**EXPEDITED**  
**MONTGOMERY COUNTY HISTORIC PRESERVATION COMMISSION**  
**STAFF REPORT**

<b>Address:</b>	5537 Lambeth Rd., Bethesda	<b>Meeting Date:</b>	9/21/2022
<b>Resource:</b>	Contributing Resource <b>Greenwich Forest Historic District</b>	<b>Report Date:</b>	9/14/2022
<b>Applicant:</b>	Matt Felts & Dane Grossnickle	<b>Public Notice:</b>	9/7/2022
<b>Review:</b>	HAWP	<b>Tax Credit:</b>	n/a
<b>Case No.:</b>	1005210	<b>Staff:</b>	Dan Bruechert
<b>Proposal:</b>	Driveway Replacement and New Retaining Wall

Drawing  
#2

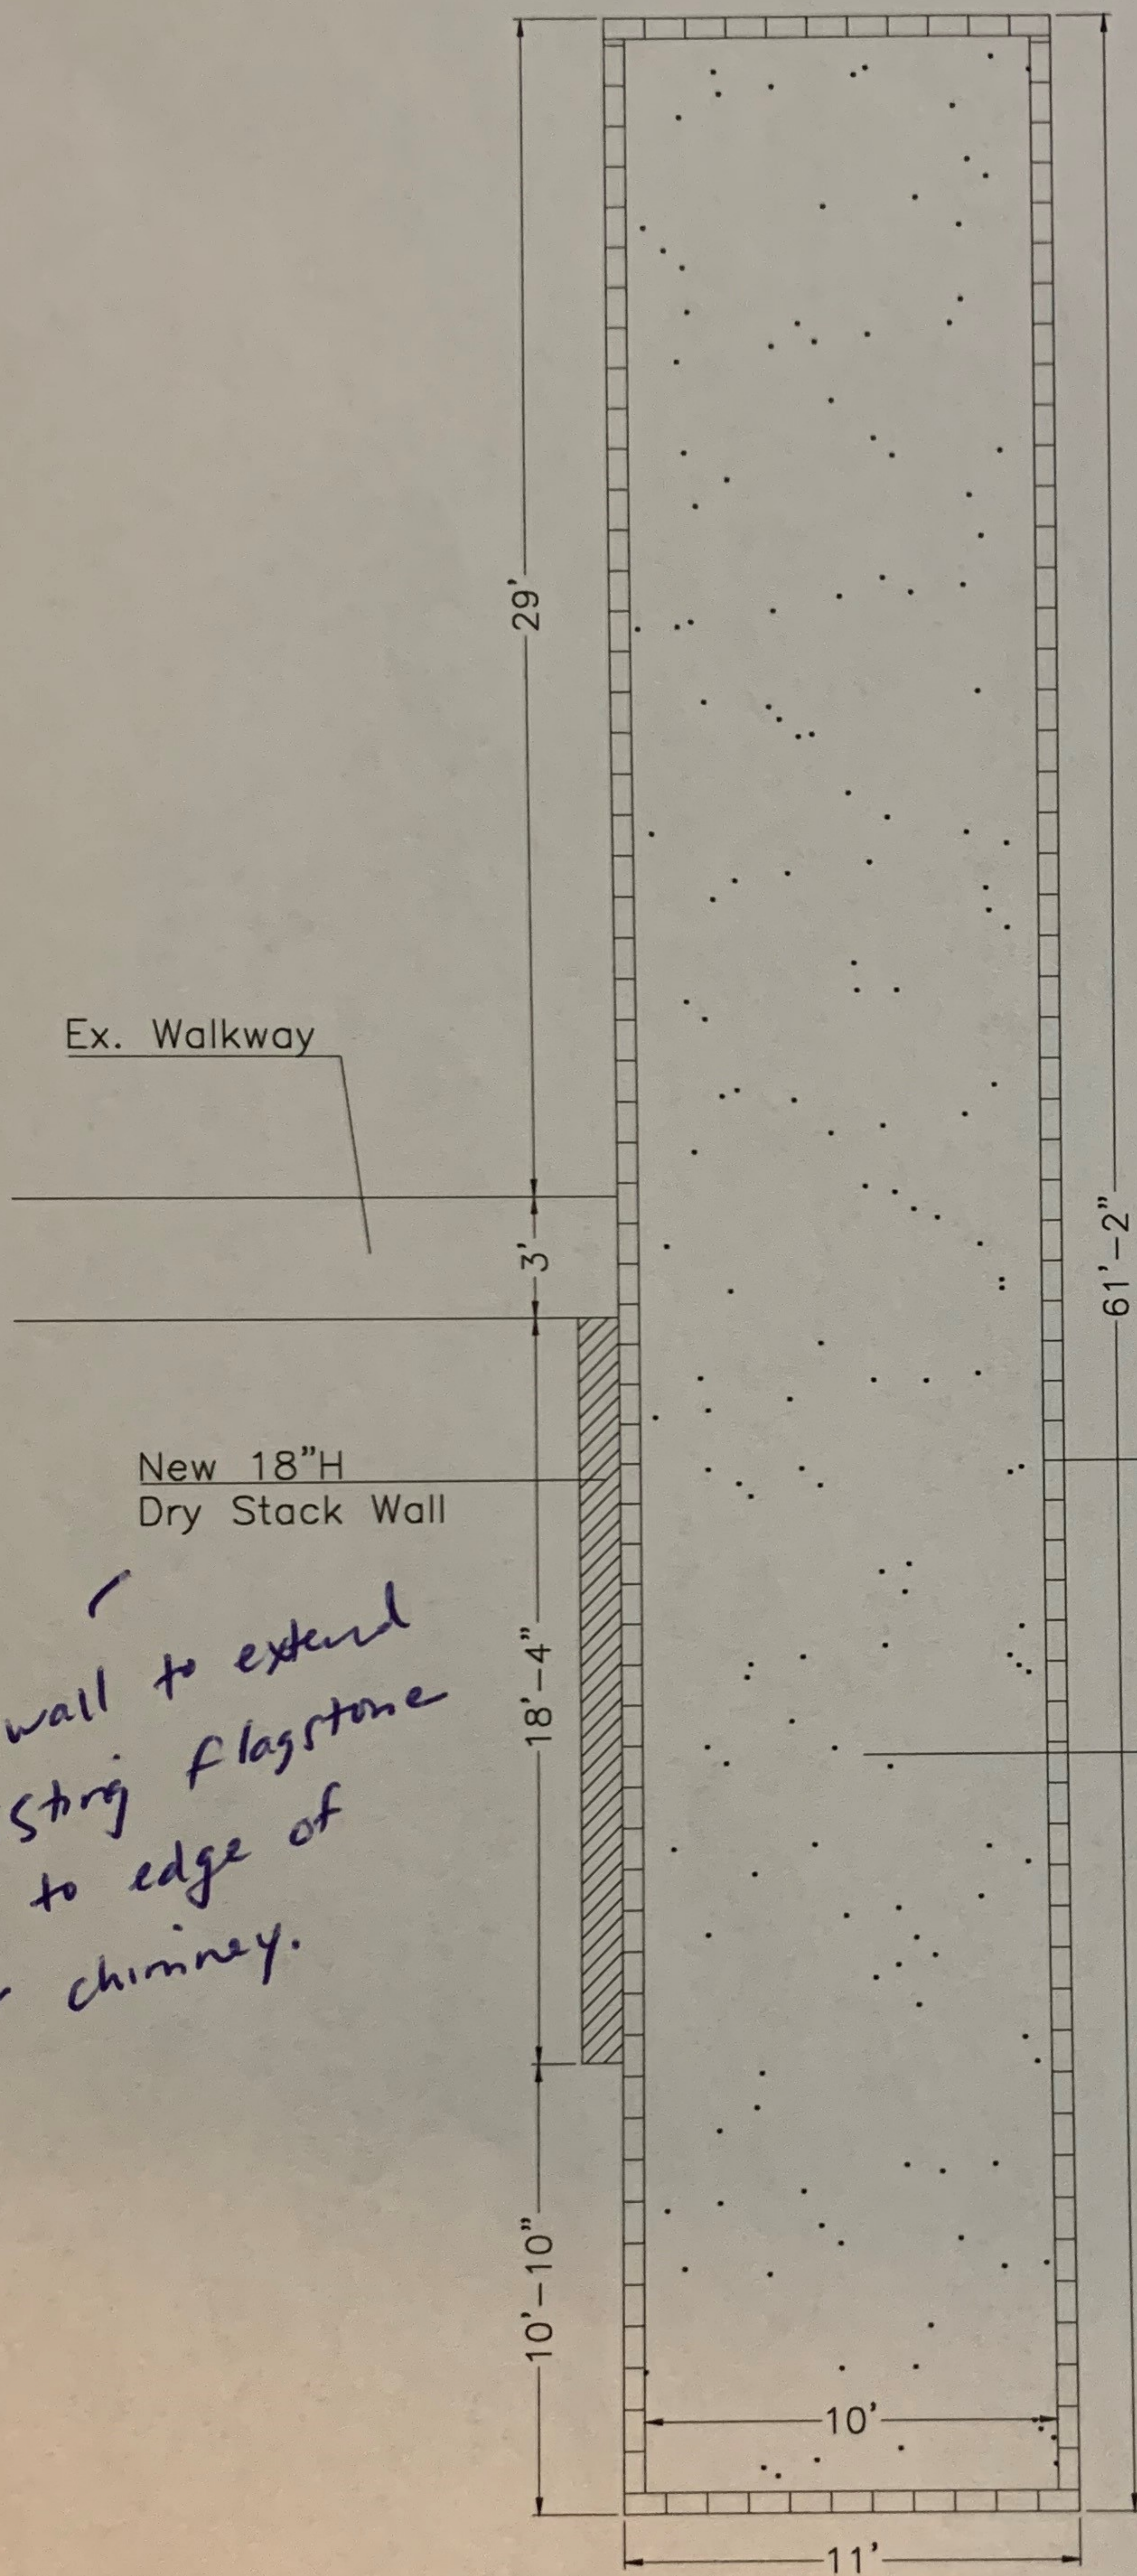
Staff finds the proposed changes will have a minimal impact on the character of the property or surrounding district. However, the HPC typically requires new concrete driveways and walkways to be tinted or have exposed aggregate to avoid the incompatible bright white appearance of contemporary concrete in a historic district setting. Staff recommends the HPC add a condition to the approval of this HAWP, that the concrete installed in the driveway is either tinted or has exposed aggregate, so the new driveway better blends in with the surrounding historic district.

1. The concrete for the proposed concrete drive needs to be either tinted or have exposed aggregate so the new driveway blends in with the surrounding district. Final approval authority to ensure this condition has been satisfied is delegated to Staff.
